Addendum No. 2

**The State of Connecticut
Department of Housing (DOH)
Community Development Block Grant
Disaster Recovery Program (CDBG-DR)
Owner Occupied Rehabilitation and Rebuilding Program (OORR)**

**Application No. 2011
Smith Residence
2 Appletree Lane
West Mystic, CT 06355**

Figure 3.2.3C: An underground fuel tank anchored to a concrete counterweight
Courtesy of Adamson Global Technology Corp.

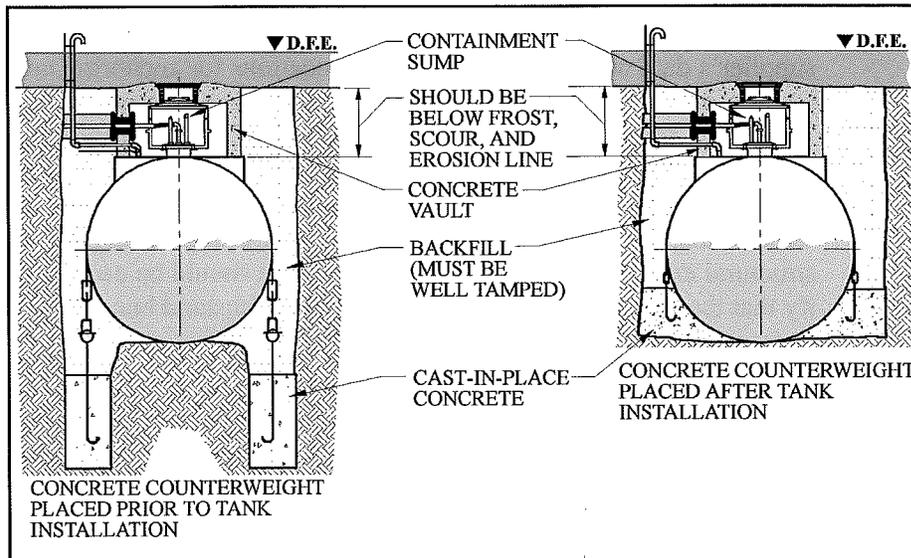
3. The existing chimney shall be removed as indicated on the plans and elevations.
4. The new propane tank is an underground propane tank with a concrete pad and straps. See Figure 3.2.3C (attached). Straps equal to Minute Man Anchors, Inc., galvanized and sized to fit tank, provide 3 straps with minimum capacity of 1,865lbs. Provide concrete pad capable of resisting an upward force of 5,585lbs. New pad shall be 5'x6'x18" minimum and extend beyond the new propane tank by 6" minimum and be reinforced at the bottom with #5 rebar at 12" on center, each way.
